City of Portsmouth Planning Board

Property Address: 806 Route 1 Bypass

Application #: LU 22-81

806 US Route 1 Bypass
Project Description

TITLE
EASEMENT PLAN
 806 US-1 BYP.
 PORTSMOUTH, NH 03801
 TAX MAP 161, LOT 43

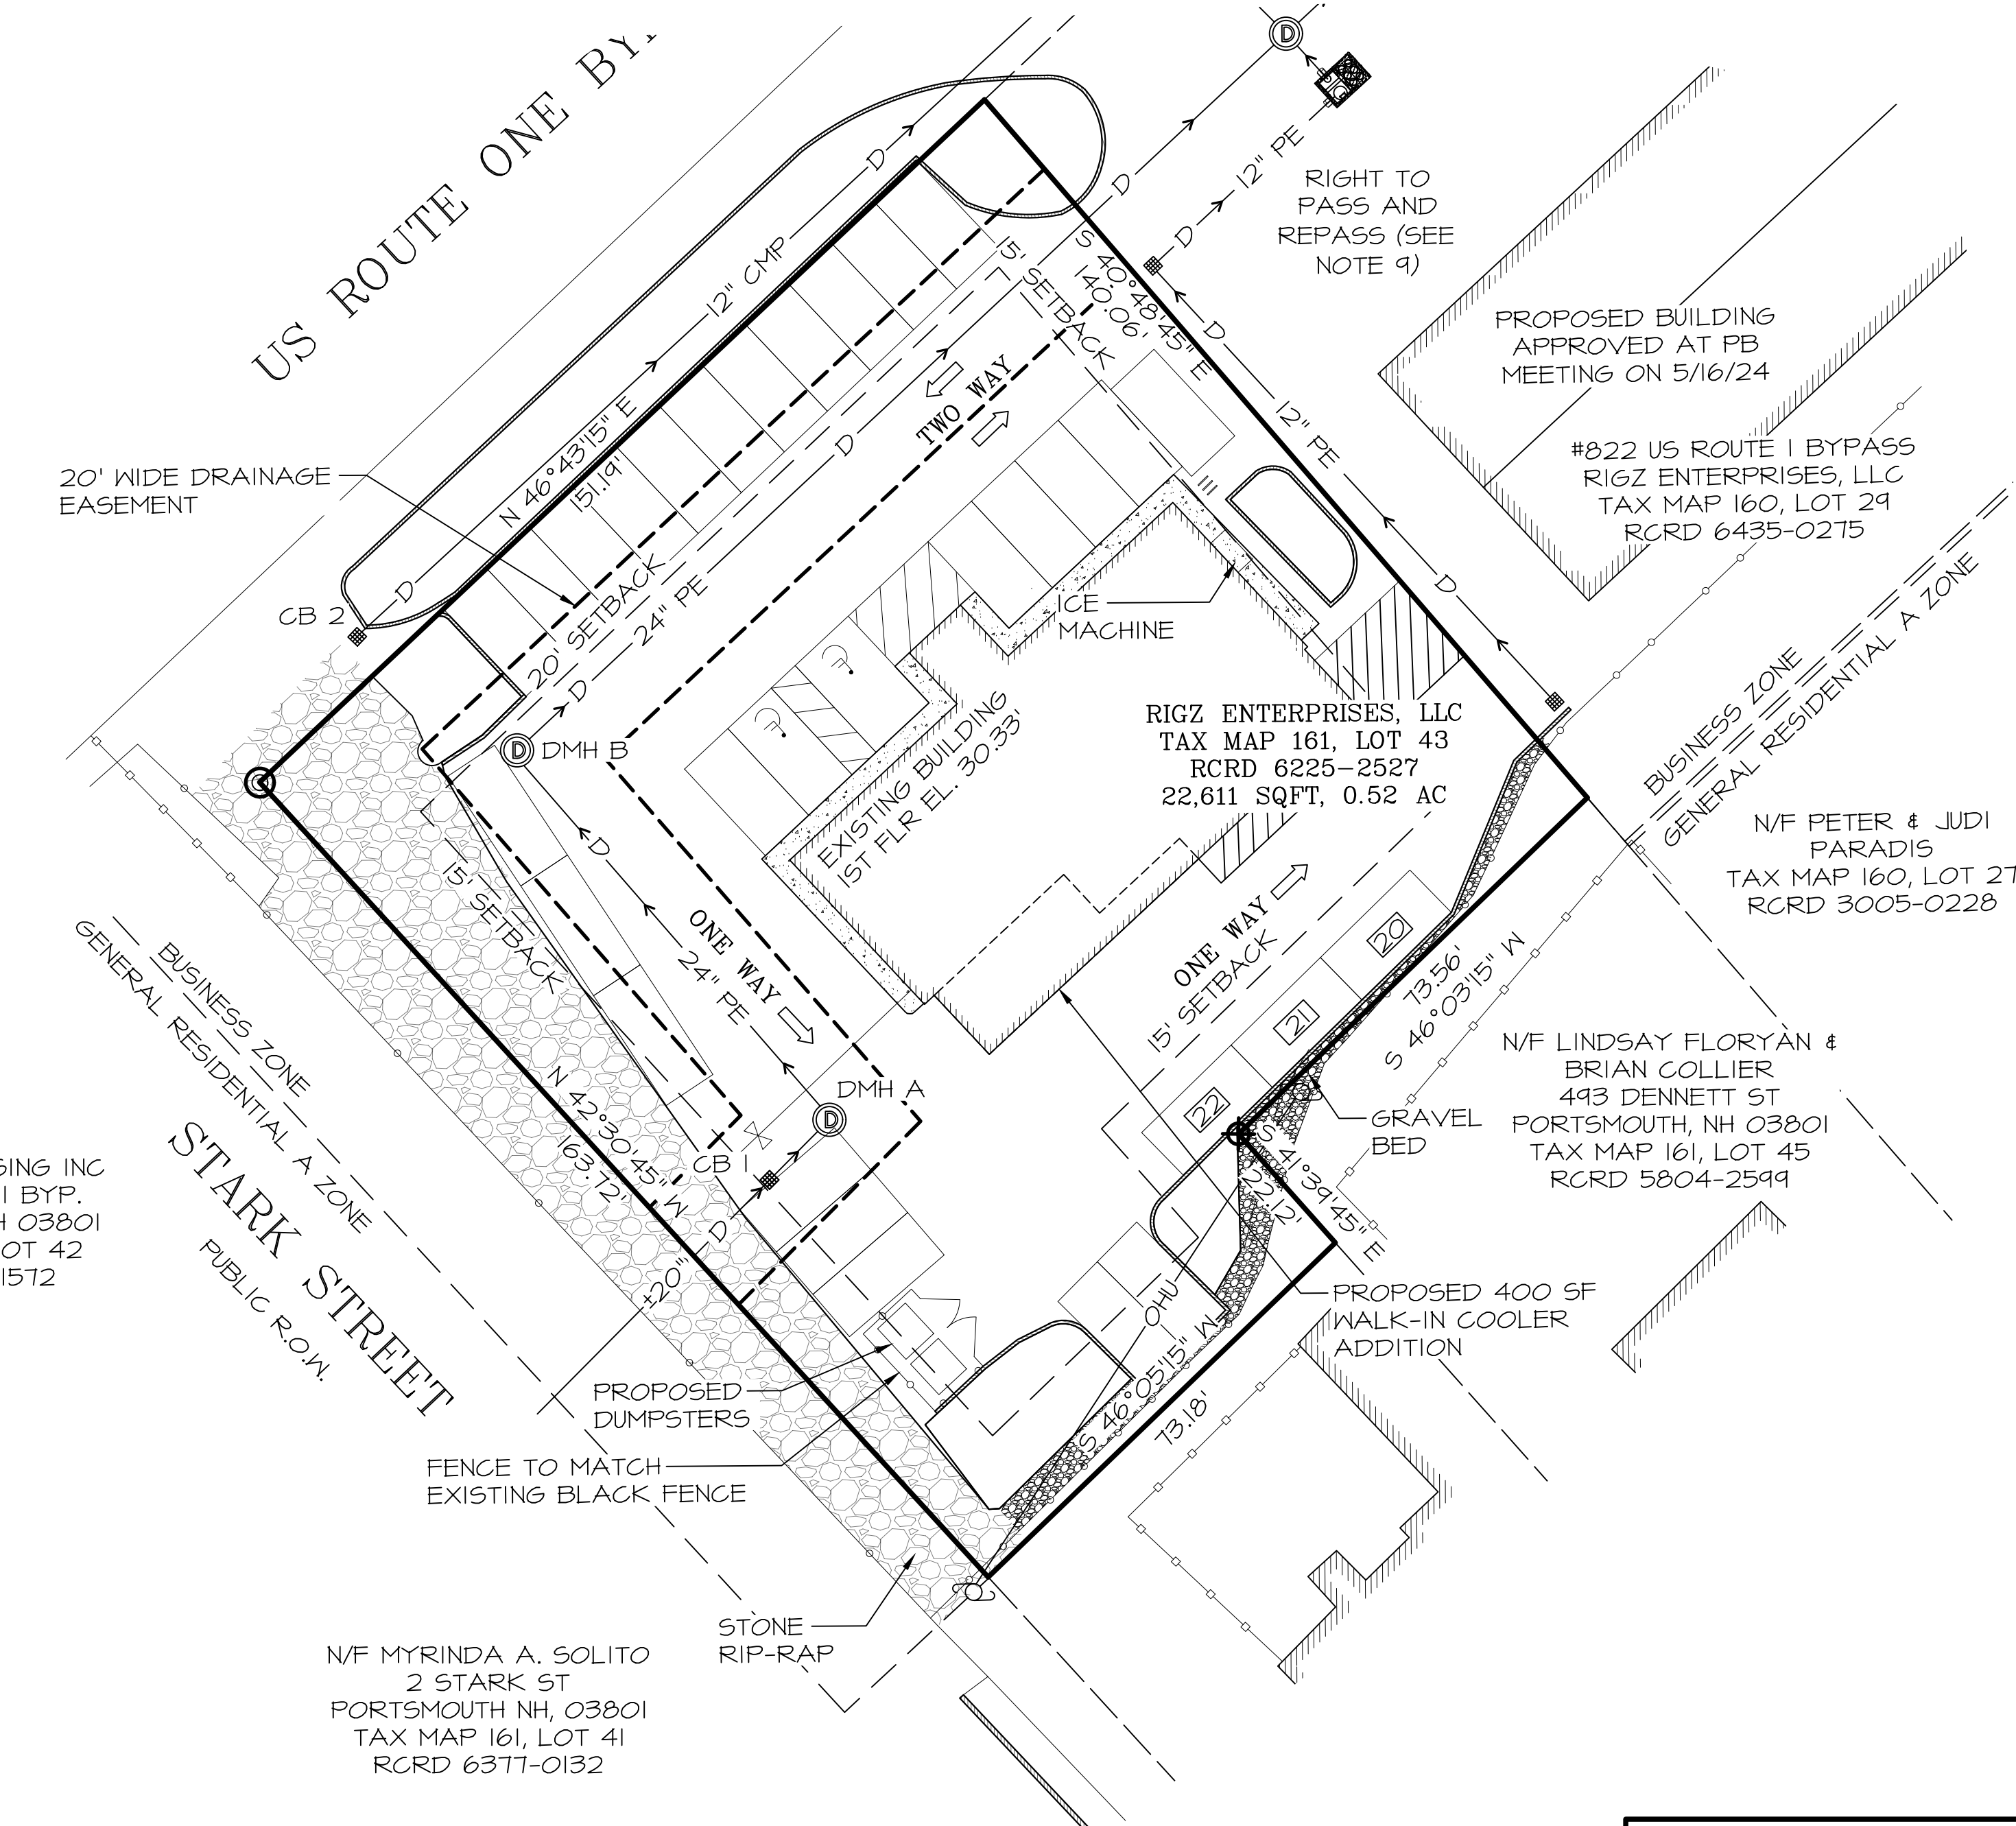
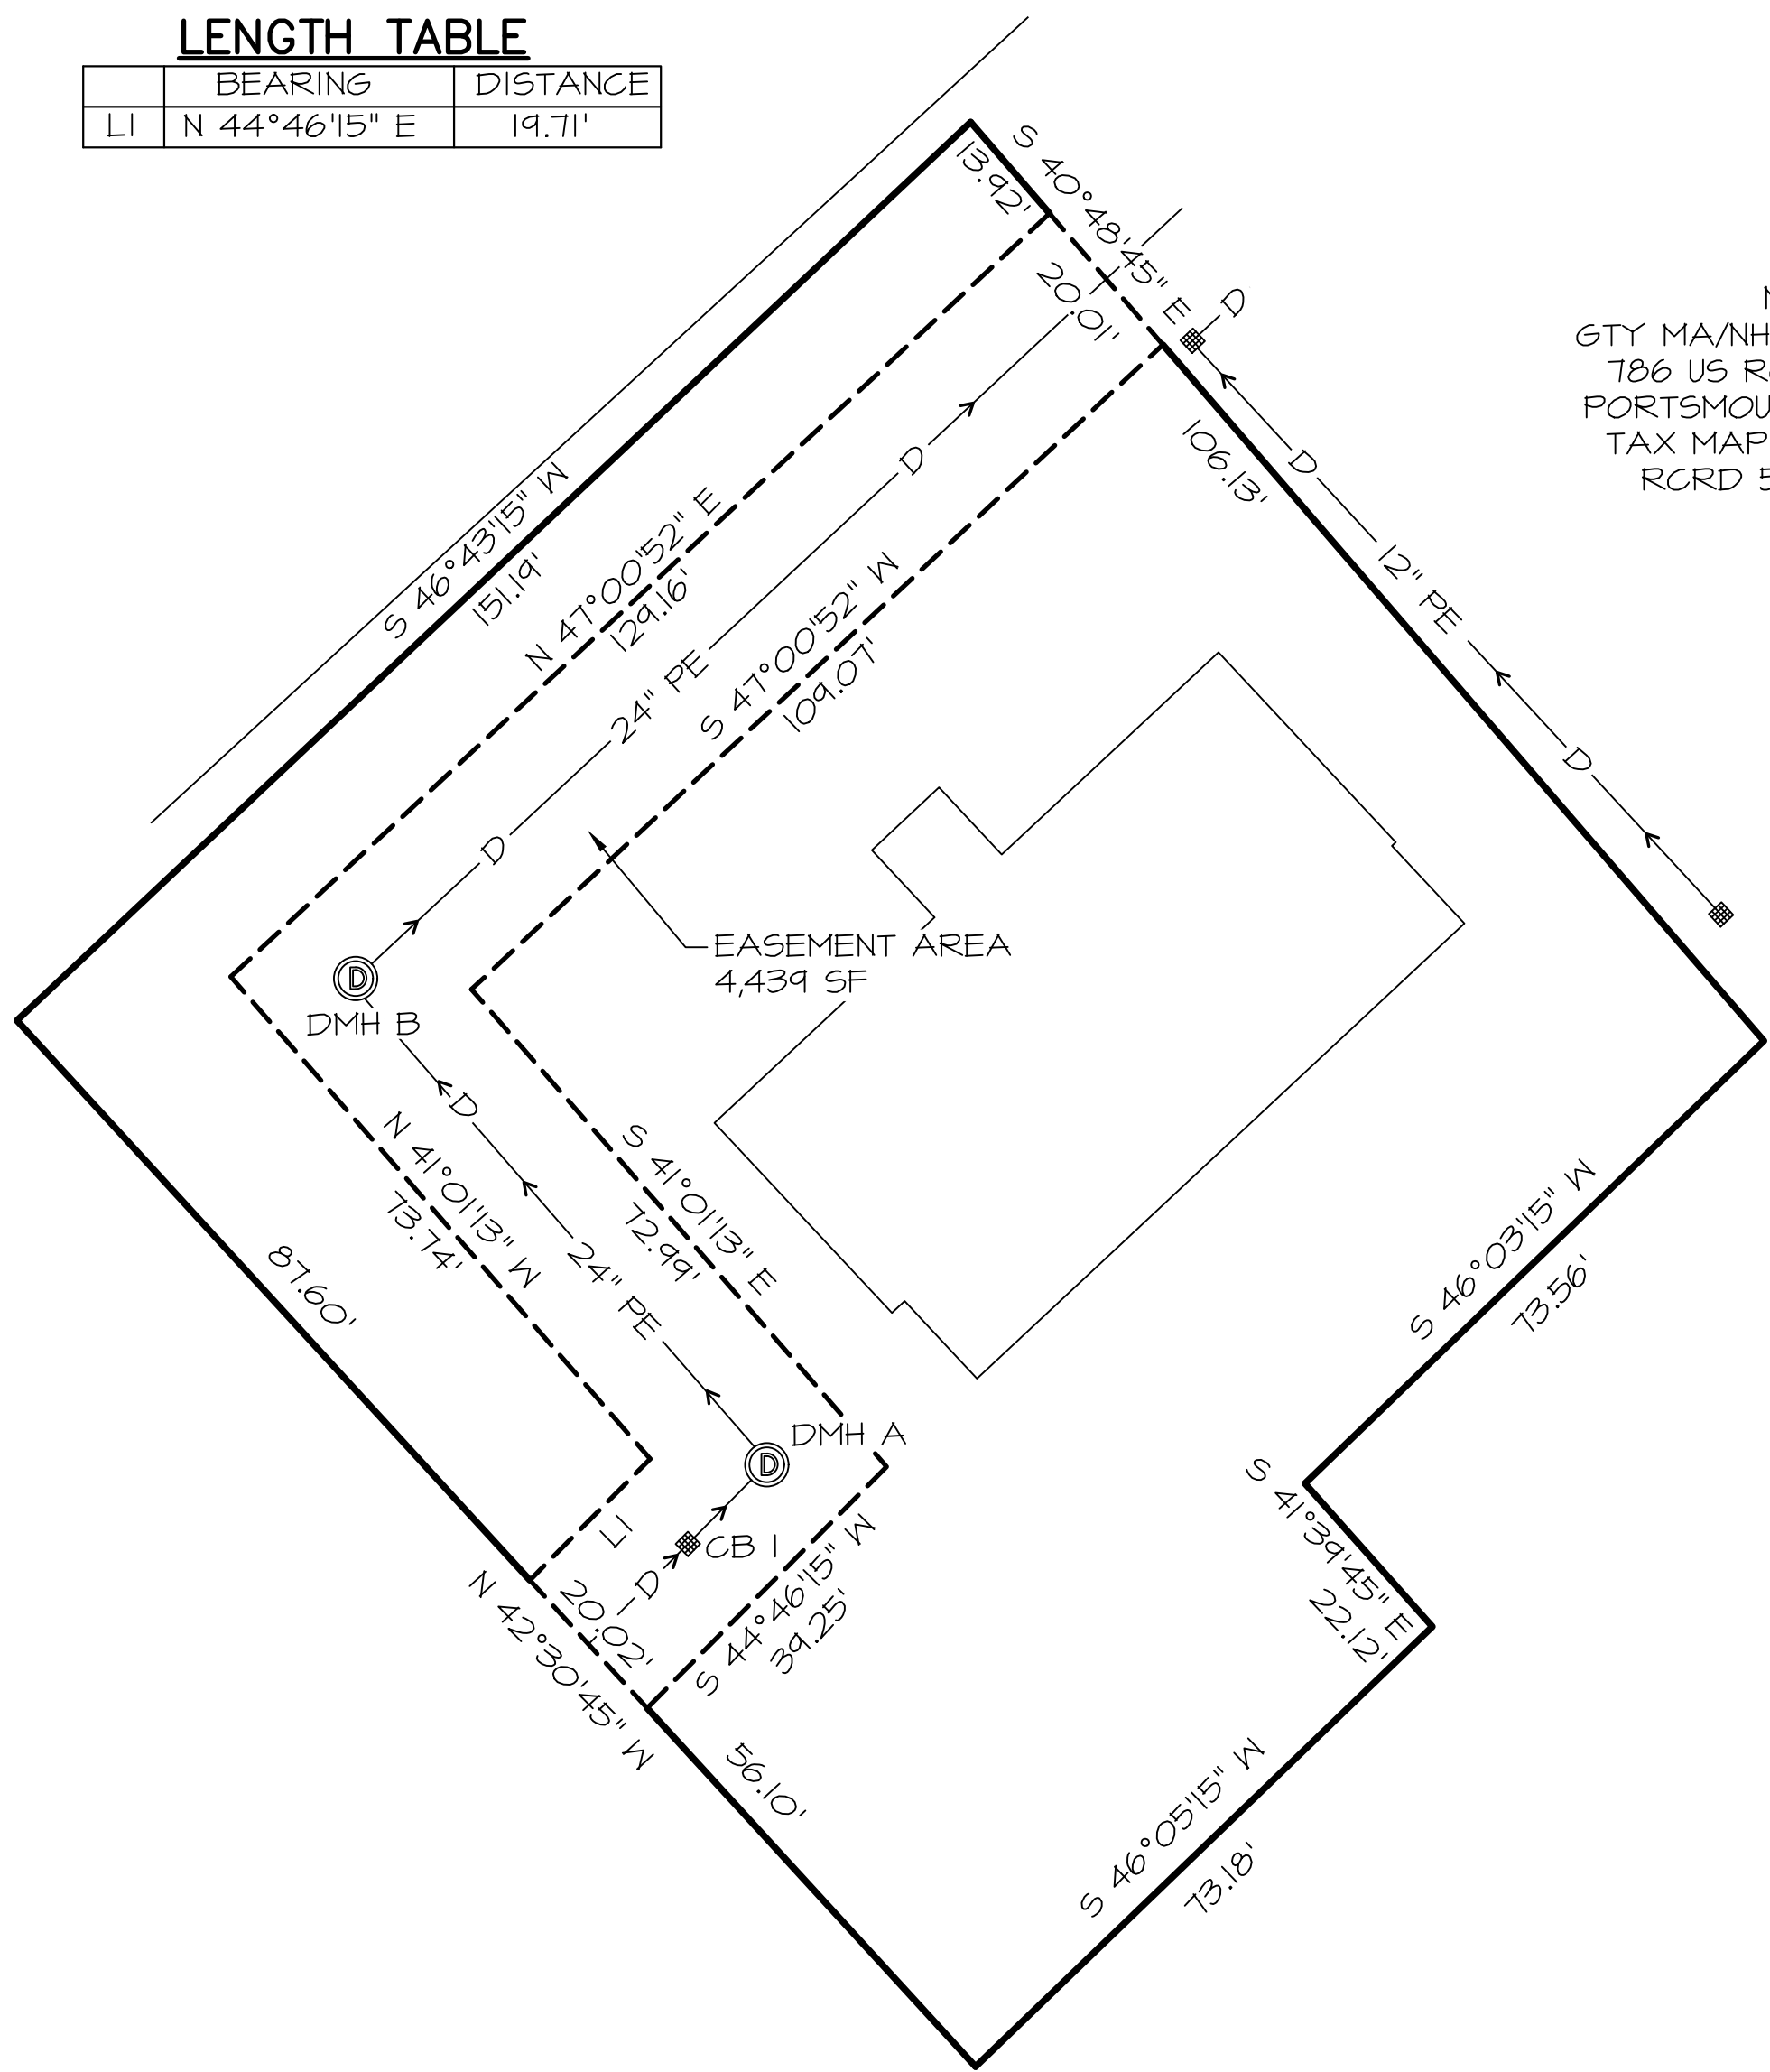
Drawing 5 –Easement Plan

- Easement Plan has been added as drawing 5 showing a drainage easement across Lot 43.

AMENDED EASEMENT PLAN
 • EASEMENT PLAN ADDED SHOWING DRAINAGE EASEMENT ACROSS LOT 43.

A drainage easement has been shown on drawing 5 “Easement Plan”,

JOB NUMBER 21-072
DWG. NO. 6 OF 7
ISSUE 8

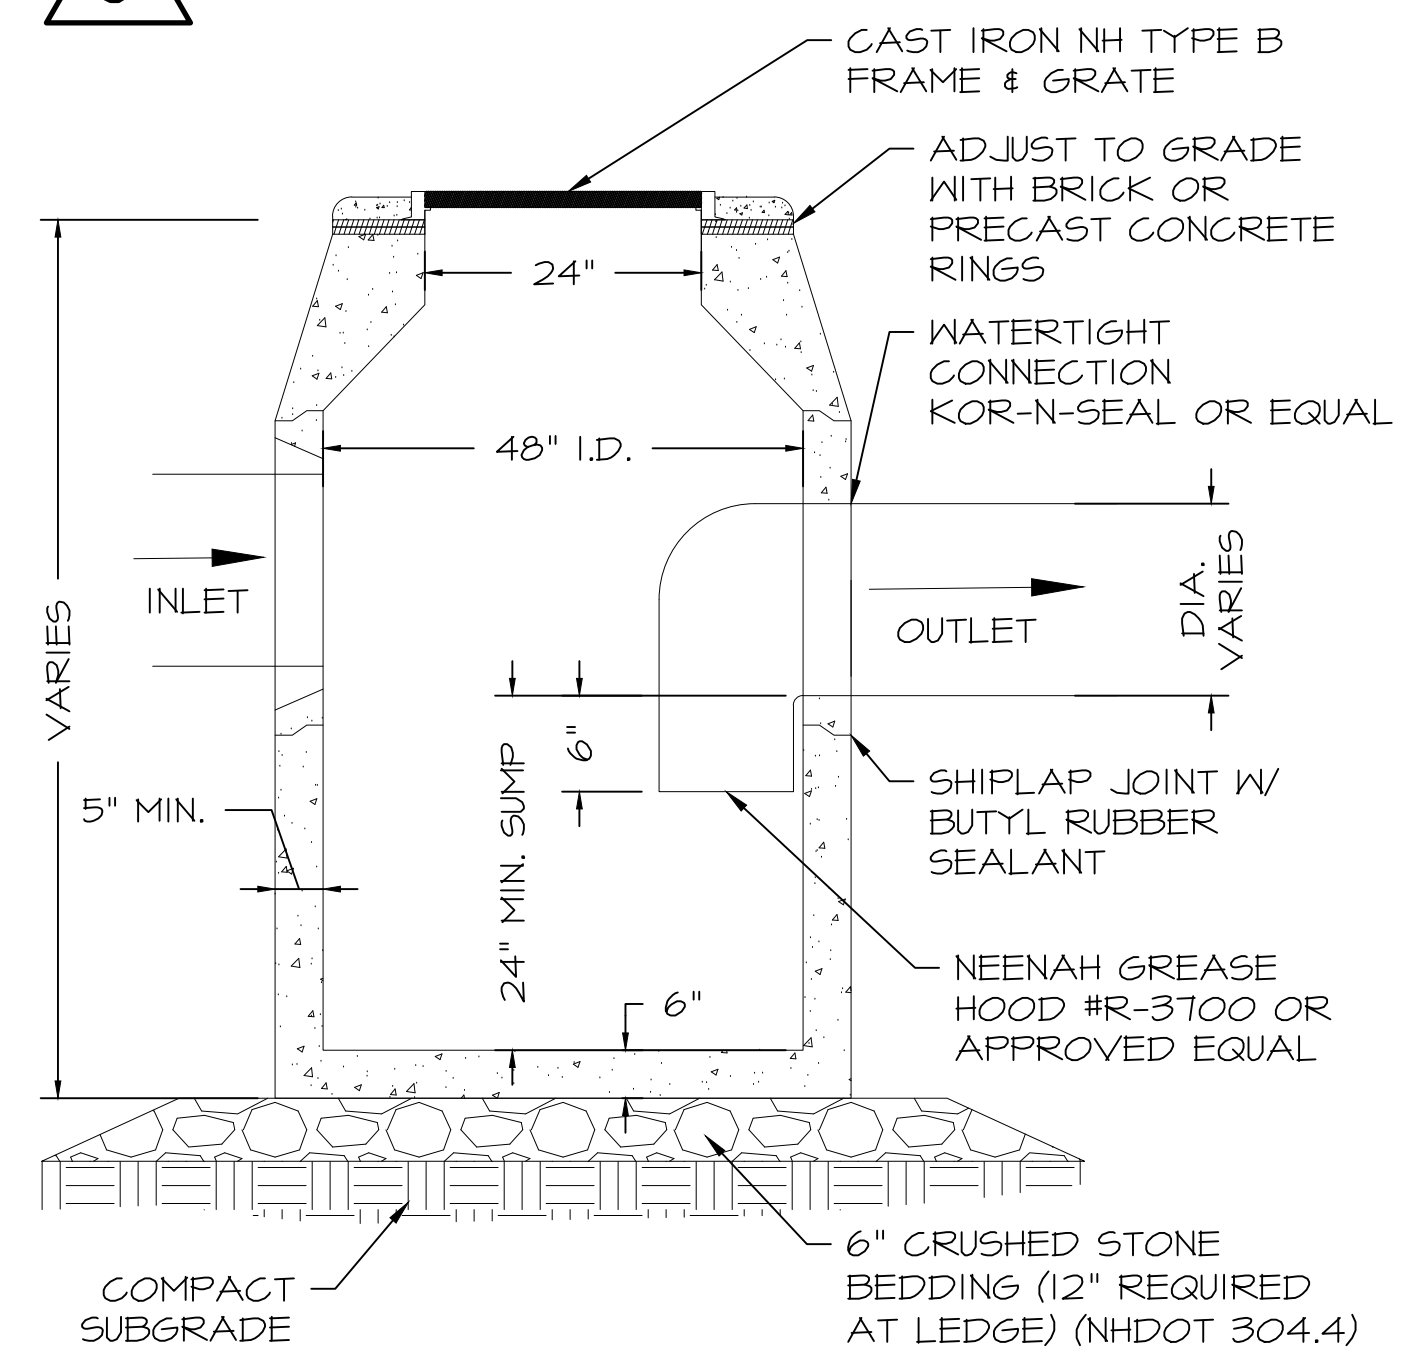
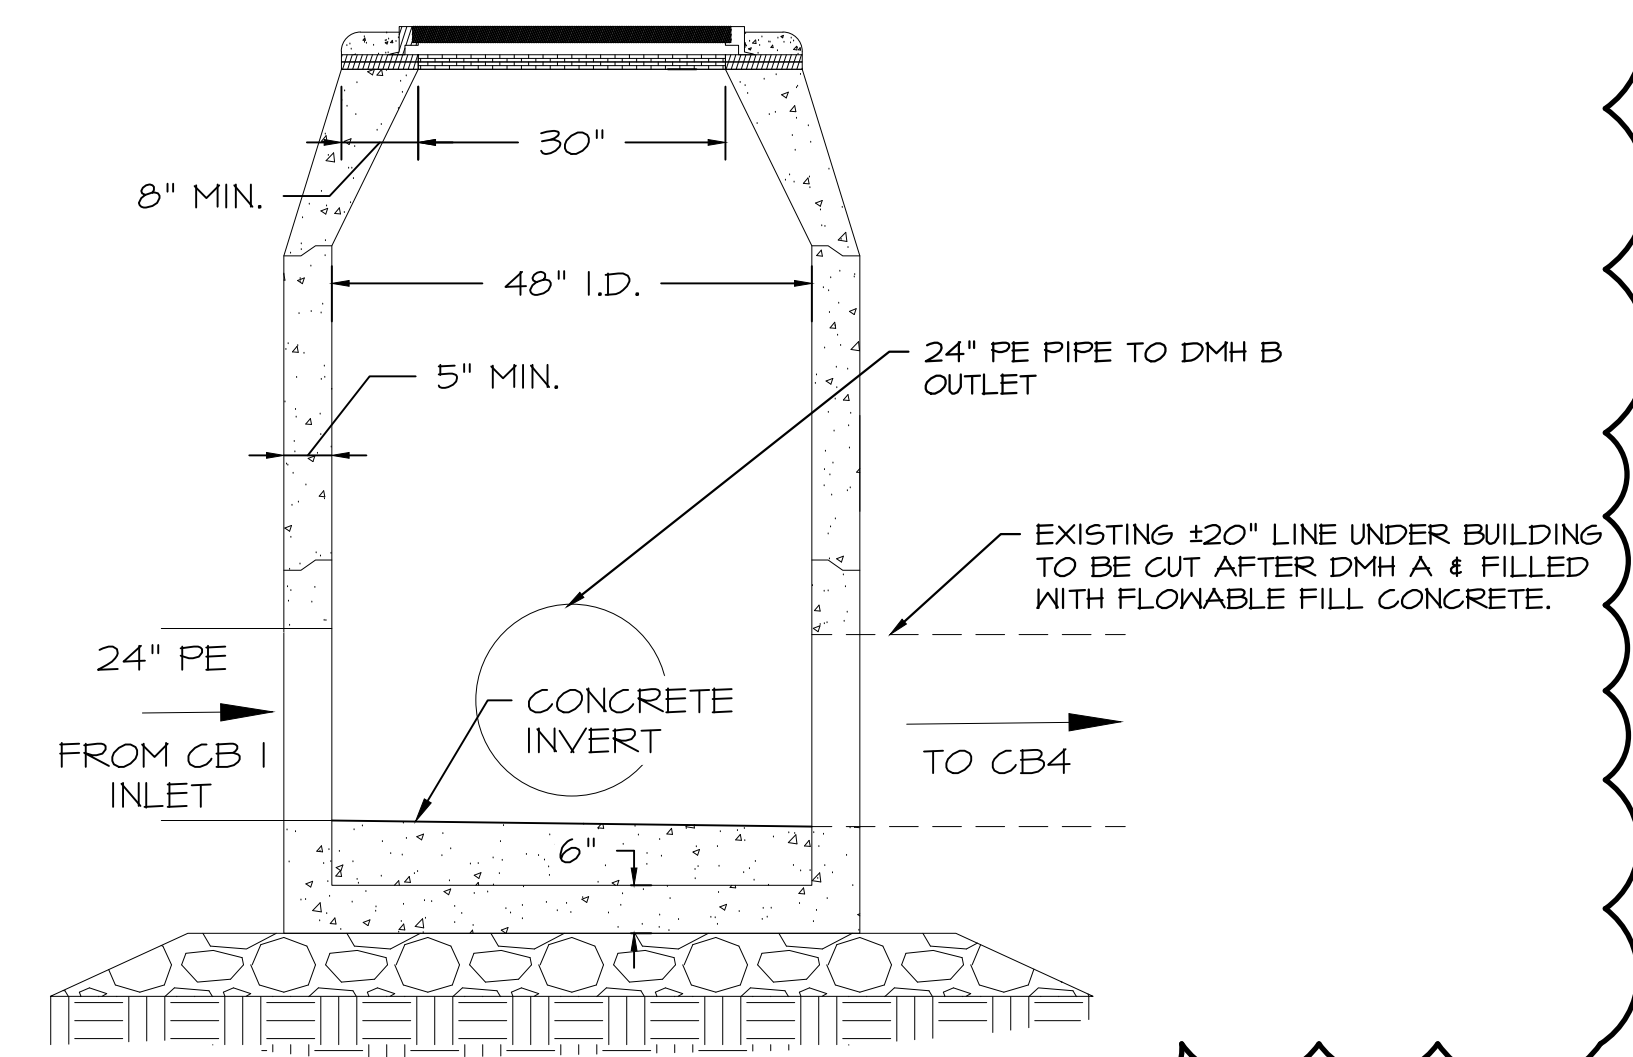
Drawing 6 – Notes & Details

- Revised manhole & catch basin details.

AMENDED DETAILS PLAN
• MANHOLE & CATCH BASIN DETAILS REVISED
